ADDENDUM NO.: 1  
 DATE OF CMR ADDENDUM: 10.16.13

**Notice of Construction Manager-at-Risk (CMR)  
 Addendum  
 on behalf of the  
 CT Department of Construction Services (CT DCS)**

<b>Project Name:</b>	<b>Southern Connecticut State University Buley Library Renovation</b>
<b>Project Location:</b>	<b>New Haven, CT</b>
<b>Project Description:</b>	<b>Phase III – 3<sup>rd</sup> and 4<sup>th</sup> Floor Fit-out</b>
<b>Project Construction Budget:</b>	<b>8 Million</b>
<b>CT DCS Project Number:</b>	<b>BI-RS-225B CMR</b>

ADDENDUM #001: BIDDING RFI LOG

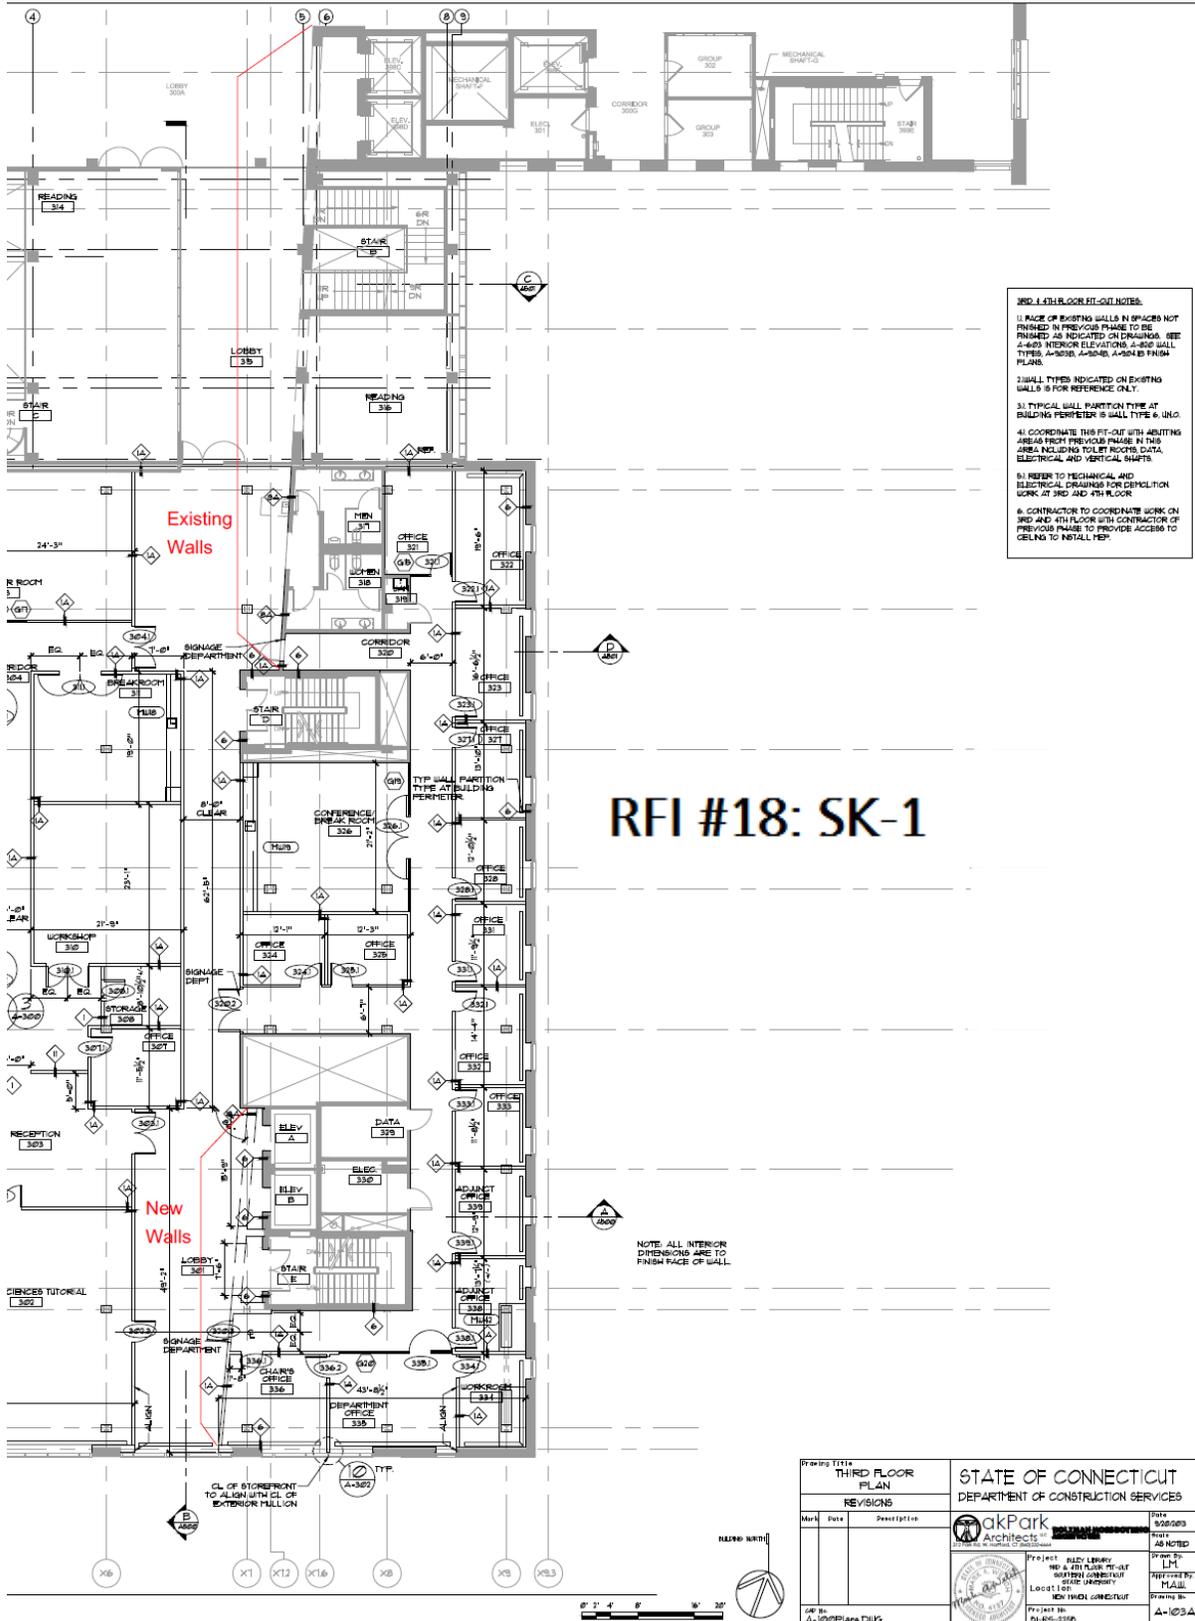
18. Reference: Drawing A-103A, A603 Detail \_\_\_\_\_ Spec \_\_\_\_\_

**QUESTION:** Please confirm that the plywood backing for tackable wall surfaces and PLAM panels, which is included in BP09, is only required in locations marked in the attached SK-1 and SK-2 as "new walls," and the plywood backing for the areas marked "Existing Walls" will be completed under previous phase. The third floor plan has been provided, but the same condition exists on the fourth floor.

**SKANSKA RESPONSE:** Reference response to RFI #10. OPA response states Lobby 315 and Lobby 439 were completed under a separate phase (Space Between Column Line XK and XH).

You will be attaching backing to metal studs provided in Phase 2 where existing partitions are indicated (i.e., corridor side of Men 317, Women 318, Men 431, and Women 432).

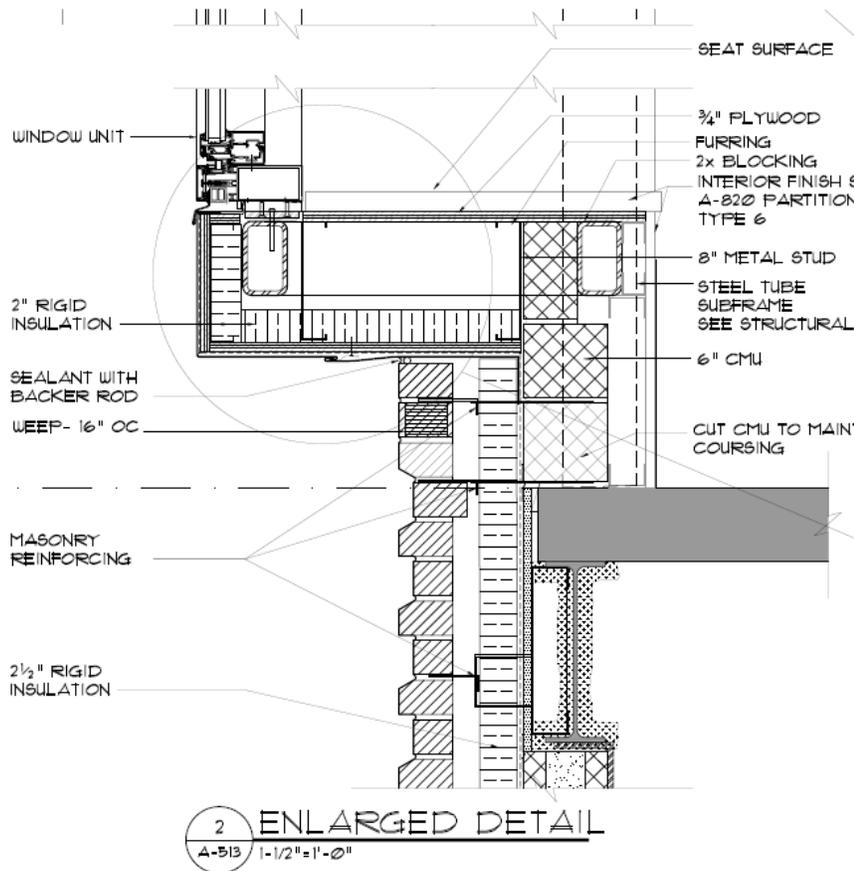
19. Reference: Drawing A-103A, A104A, & A501 Detail \_\_\_\_\_ Spec \_\_\_\_\_

(A) On floor plan A-103A, rooms 303A and 304A are labeled "Seating". The window sill at these locations appears to be different than the typical solid surface window sill per detail 11/A-302. It is significantly deeper and wider. Is it just a deeper and wider solid surface sill, or is it some kind of built-in window seat or bench? The floor plan indicates there is a section through the window in 304A at detail D/A-501. The section on A-501 does not clearly indicate what is happening at that window. Is there a detail available to clarify the millwork required at the windows in these seating areas?

(B) Floor plan A-104A shows similar windows at rooms 403 and 409 but these rooms are labeled "Office" not "Seating". What occurs here? Is it the same as the detail for rooms 303A and 304A?

- (a) It is the same just deeper, Solid Surface #3, 2'-0" deep (V.I.F.), refer to 2/A-513 for reference below.
- (b) Yes, same detail.
